Access Compliance Report Public Rights-of-Way (Curb Ramps)

Intersection ID: 13367 Main Street: WESTWOOD AV Cross Street: WICKFORD PL Location: ADA ID: 2EE710B65A2A Ramp Type: Perp Initial Pass/Fail: Fail **Overall Compliance: No Severity Score:** 12.5

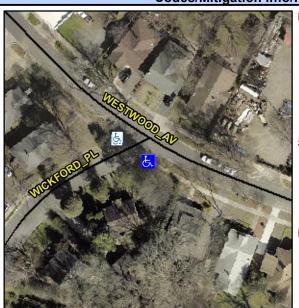
Possible Solutions: Remove & Replace Entire Ramp. Surveyor Notes: N/A PROW/ADA: Not Found, R304.2.2

Fleid Measurements/Component Compliance					
Compliance Description D			Compliance Description		Data
N/A	Ramp Length (in)	48.0	No	Ramp Slope (%)	9.1
Yes	Ramp Width (in)	48.0	Yes	Ramp XSlope (%)	0.8
N/A	Flare Type LT	N/A	N/A	Flare Type RT	N/A
N/A	Flare Slope LT (%)	N/A	N/A	Flare Slope RT (%)	N/A
N/A	Flare Traversable LT?	N/A	N/A	Flare Traversable RT?	N/A
N/A	Landing Length (in)	N/A	N/A	DWS Provided?	N/A
N/A	Landing Width (in)	N/A	N/A	DWS Contrast?	N/A
N/A	Landing Slope (%)	N/A	N/A	DWS Length (in)	N/A
N/A	Landing X Slope (%)	N/A	N/A	DWS Full Width?	N/A
N/A	Landing Curb? (Y/N)	N/A	N/A	DWS Offset (in)	N/A
N/A	Shared Landing?	N/A			
N/A	Gutter Ponding?	N/A	N/A	Gutter Slope (%)	N/A
N/A	Gutter Lip Ht (in)	N/A	N/A	Gutter X Slope (%)	N/A
N/A	Painted X Walk1?	No	N/A	Painted X Walk2?	N/A
	X Walk 1 Direction	To NW		X Walk 2 Direction	N/A
N/A	X Walk 1 Width (in)	N/A	N/A	X Walk 2 Width (in)	N/A
	X Walk 1 Slope (%)	2.1		X Walk 2 Slope (%)	N/A
